City of Richmond
Urban Development Division

**Report to
Development Permit Panel**

File: DP 04-272882

Re: **Application by Peter Yee for a Development Permit at
9331 General Currie Road**

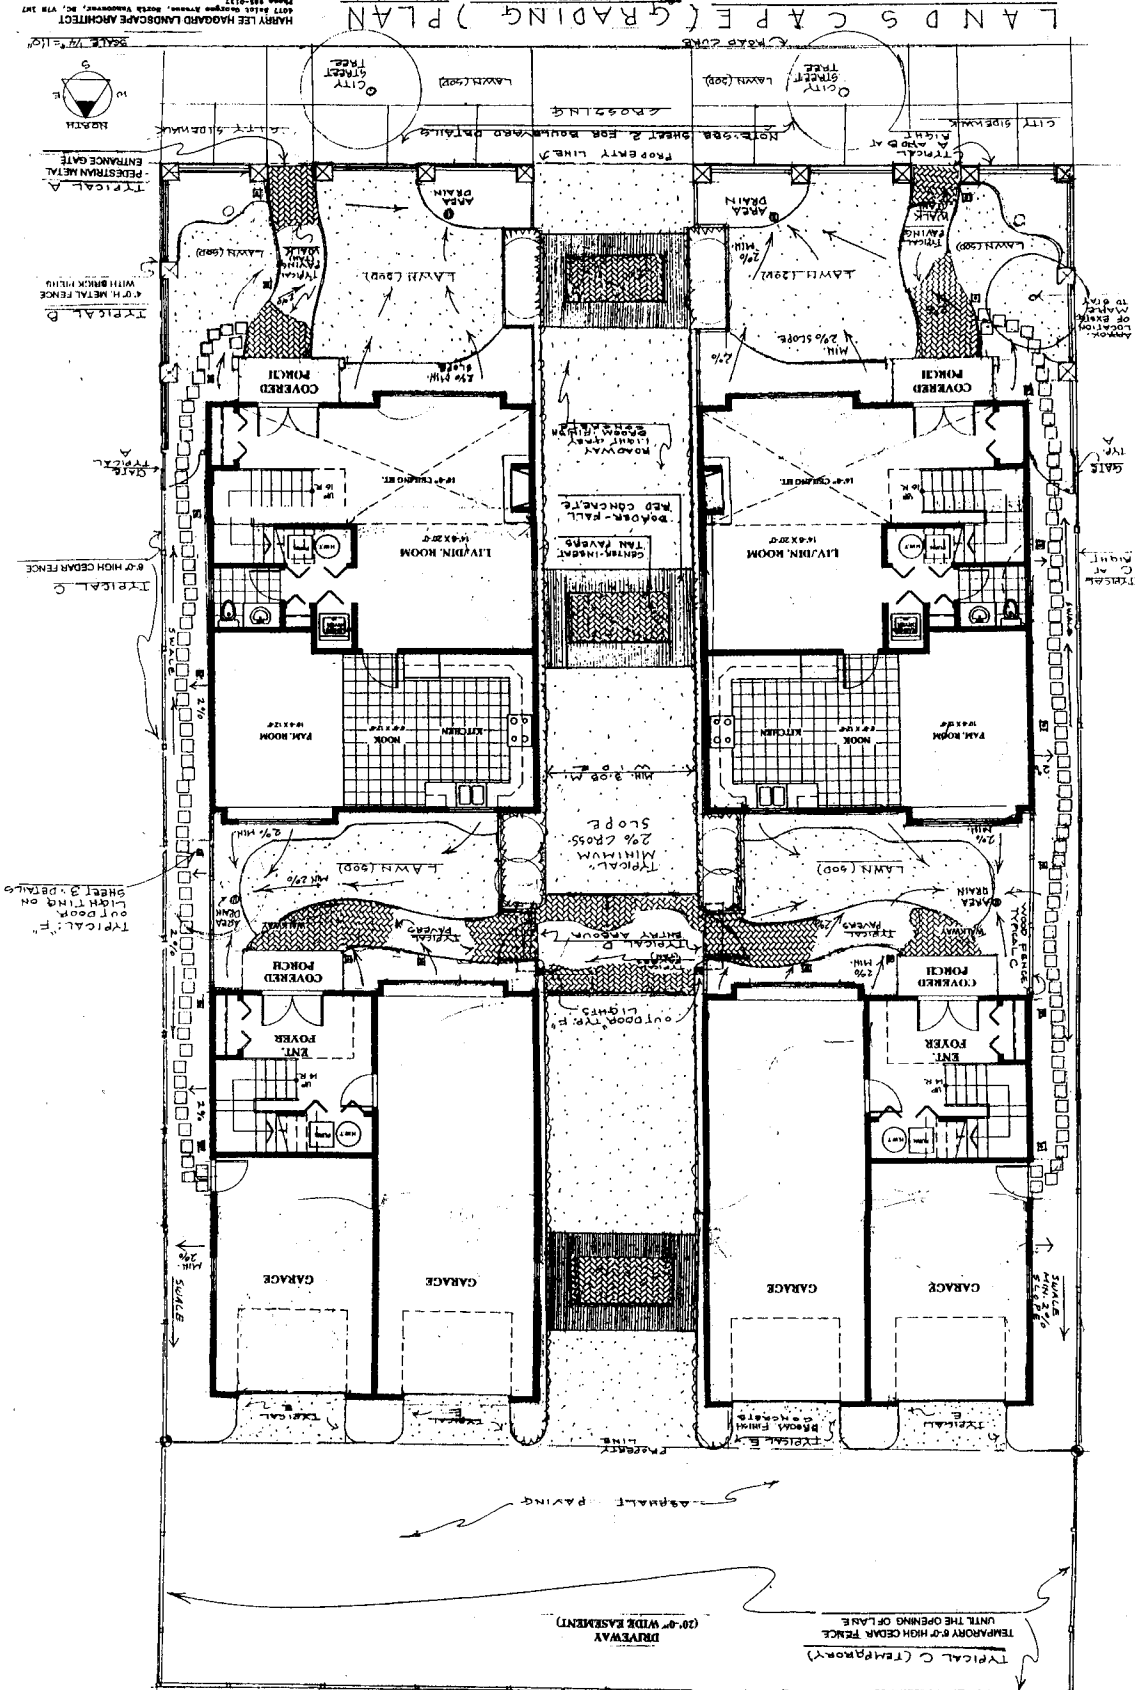
- *provision of better access to the front units from the parking;*
- *improved articulation of the interior side elevations and better delineation of each storey;*
- *the use of a combination of materials for paving;*
- *provision of landscaping along the internal driveway; and*
- *confirmation of compliance with the City's tree re-planting requirements and provision of landscaping detail for the boulevard.*

- The Development Permit application has been revised to include a landscape plan prepared by a registered Landscape Architect;
- The landscape plan has been revised to include: a combination of materials for paving; transitional landscaping strips along the internal driveway including low shrubs, low fencing and trees;

- The applicant explored retention of all four (4) existing trees outside of the lane right-of-way, but unfortunately, the location of three (3) of the trees conflicts with building envelopes. The applicant is retaining one (1) existing clump ornamental Maple tree in the front yard setback. The remaining three (3) trees will be replaced with 26 new trees; and

- The landscape plan shows City boulevard treatment including a sidewalk pulled back from the curb, street trees, and a grass boulevard. Frontage improvements including those mentioned will be secured and confirmed through a required Servicing Agreement prior to Building Permit issuance.
